PUBLIC PARTICIPATION

3. COMMENT AND RESPONSE REPORT

PROPOSED MAINTENANCE OF THE KM 8.920 CULVERT, WAARBURGH ROAD, JOOSTENBERGVLAKTE-RIVER MAINTENANCE MANAGEMENT PLAN REPORT.

Location of Km 8.920 Culvert, Waarburgh Road, Paarl	 Tel: (021) 870 1874 Fax: 086 6933 802 Cell: 072 1571 321	
Source: Google Earth

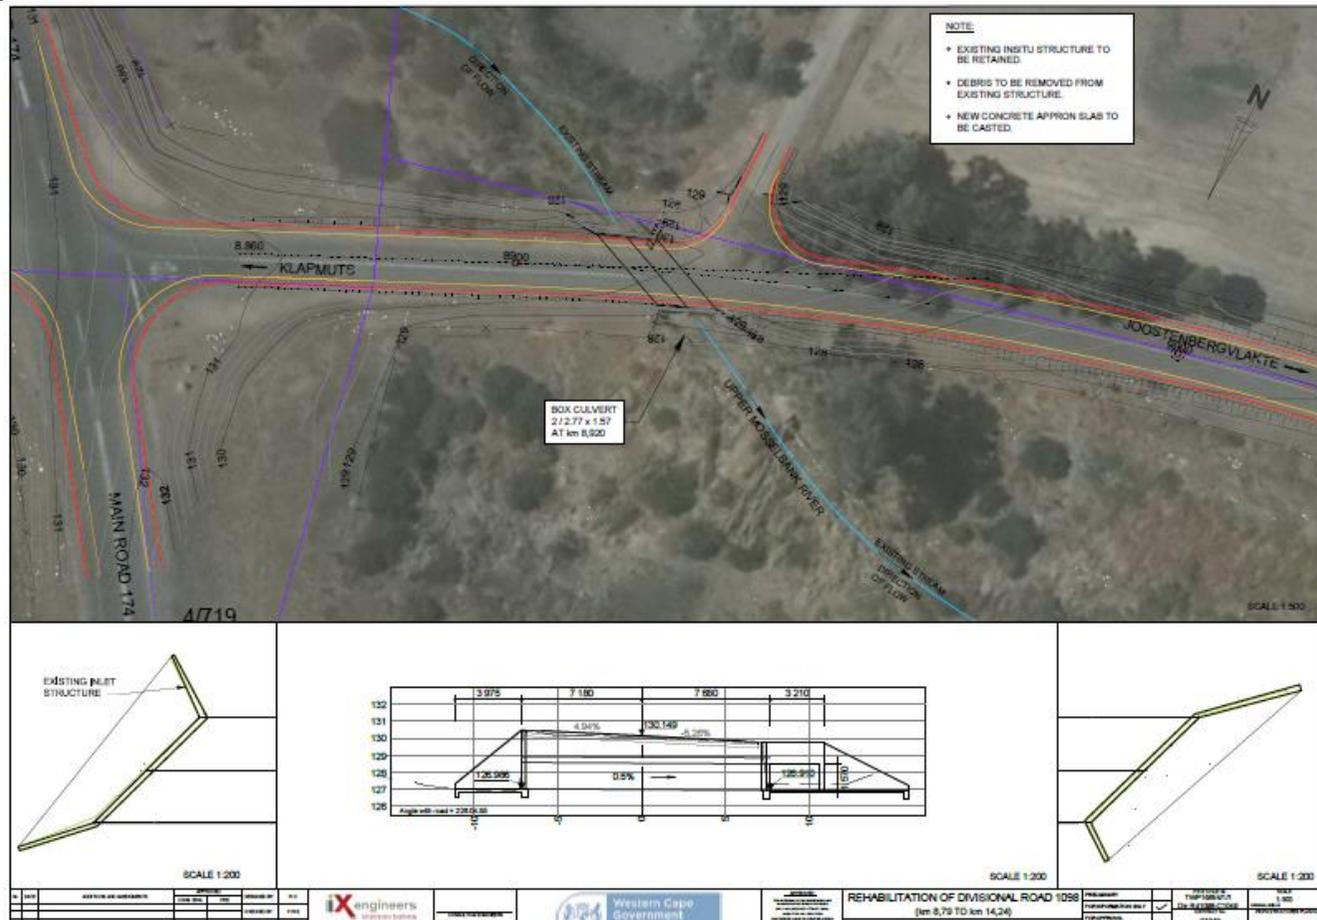
«Name»	«Date_of_Comms»	«Means_of_Comms»
Barim Richardson	10 December 2018	Email
Comment Received		
Please can you provide a Graphic Map of where the work will take place as we have a water feed from Theewaterskloof in and around the construction.		
Response		
Good Day Mr. Richardson. Please refer to the Engineer Drawing below for the location of Km 8.920 culvert on Waaburgh Road. The project Engineers confirmed that the water pipeline will not be impacted upon by the maintenance activities.
